KCL363L and KCL368L Product Update and Compatibility Notice

Fig 3

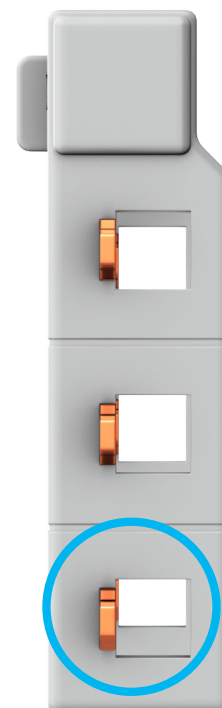
It is still possible to use but installers will lose the first pole on the left on all affected rows. (See Fig 3 & 4)
